Intel[®] Pentium[®] III Processor Specification Update

Release Date: August 2007

Document Number: 244453-058

The Pentium[®] III processor may contain design defects or errors known as errata which may cause the product to deviate from published specifications. Current characterized errata are documented in this Specification Update.

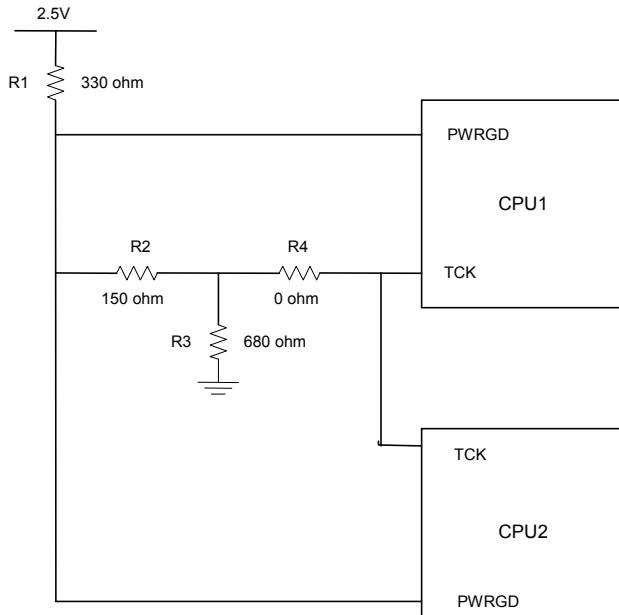
Problem: The internal control register bit responsible for operation of the Thermtrip circuit functionality may power up in a non-initialized state. As a result, THERMTRIP# may be incorrectly asserted during de-assertion of RESET# at nominal operating temperatures. When THERMTRIP# is asserted as a result of this erratum, the processor may shut down internally and stop execution but in few cases continue to execute.

Implication: This issue can lead to intermittent system power-on boot failures. The occurrence and repeatability of failures is system dependent, however all systems and processors are susceptible to failure. In addition, the processor may fail to stop execution during the event of a valid THERMTRIP# assertion resulting in the potential for permanent processor damage.

Workaround: To prevent the risk of power-on boot failures or catastrophic thermal failures, a platform workaround is required. The system must provide a rising edge on the TCK signal during the power-on sequence that meets all of the following requirements:

- Rising edge occurs after Vcc_core is valid and stable
- Rising edge occurs before or at the de-assertion of RESET#
- Rising edge occurs after all Vref input signals are at valid voltage levels
- TCK input meets the Vih min and max spec as mentioned in EMTS
